CONSTRUCTION OF FIRE STATION ONE AND A FIRE ADMINISTRATION BUILDING PROJECT # RPSTA1 CONTRACT CONTROL # 14-100215

ADDENDUM FOUR

SEPTEMBER 20, 2013

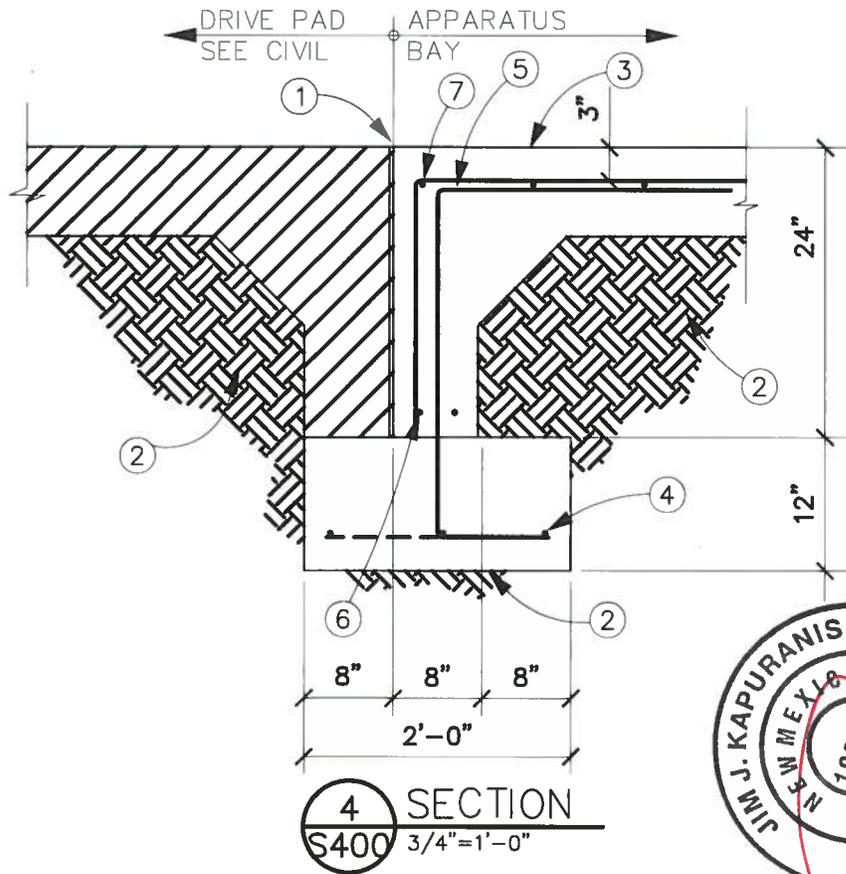
21. 4/S400 is the detail at the apparatus bay doors. We believe this to be under-designed and should have a footing under this below frost depth. *Please replace detail 4/S400 with the detail on the attached sketch S400/SK-1.*

1. 1/2" EXPANSION JOINT MATERIAL.
2. PREPARED SUBGRADE PER SOILS REPORT.
3. 8" CONCRETE SLAB-ON-GRADE SEE PLAN
4. (3) #5 CONT. (AS SHOWN).

5. #5 @ 24" O/C - DOWEL
6. (2) #5 CONT.
7. (1) #5 CONT.
